Project. **PROPOSED OFFICE DEVELOPMENT**

37 CHURCH ST.

Drawing Title. **ELEVATIONS**

Dwg. No. **P 02**

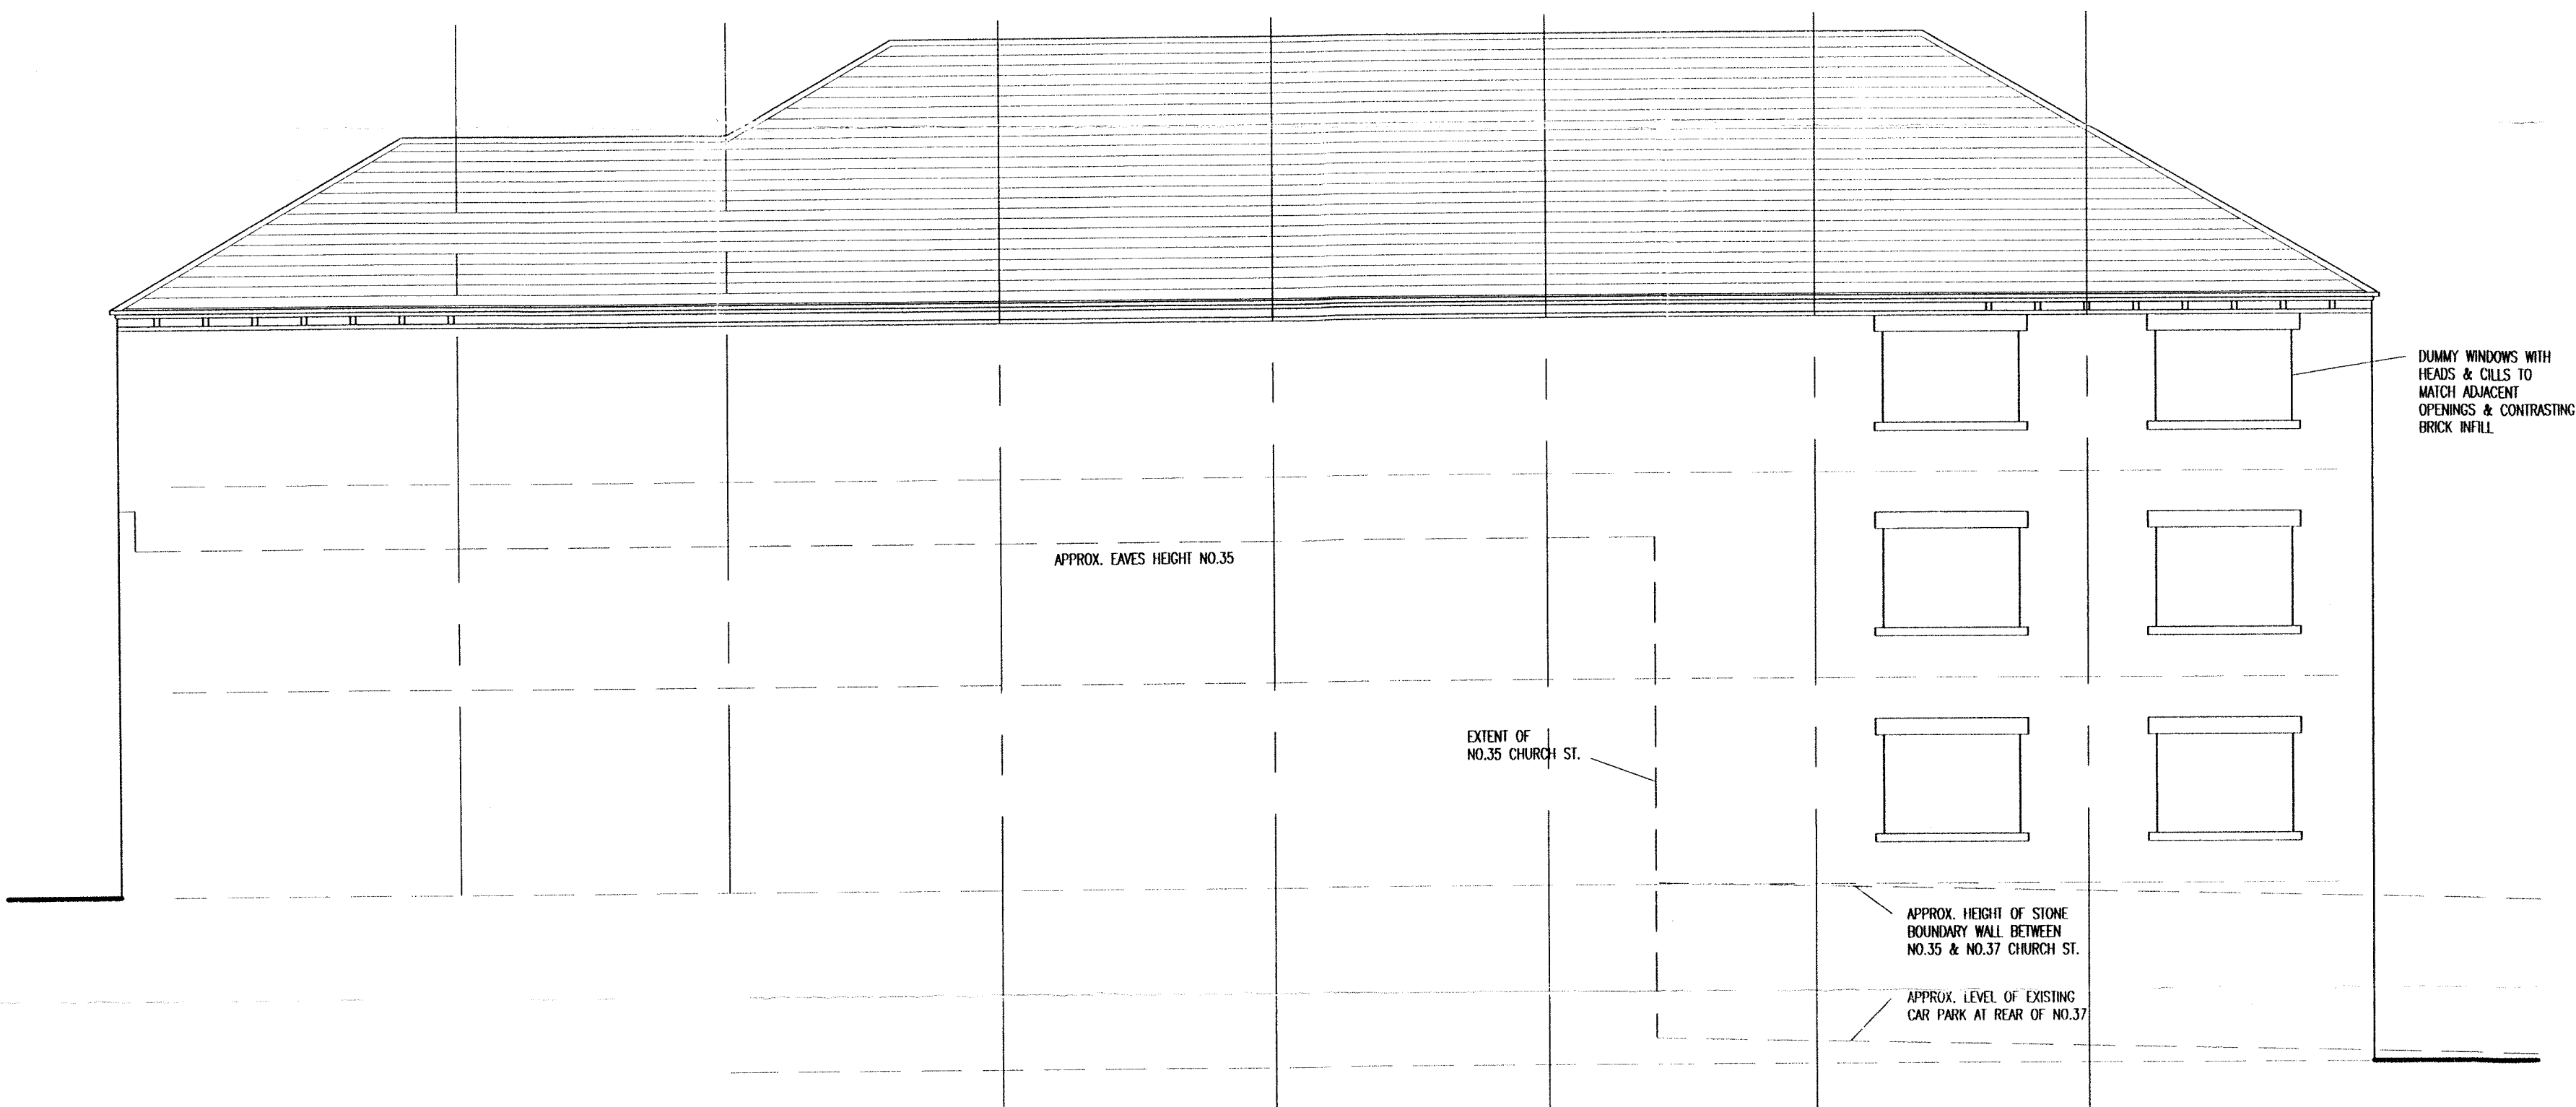
Revisions.			Revisions.		
Date	Suffix	Description	Date	Suffix	Description
12/4/5	A	WINDOW POSITIONS
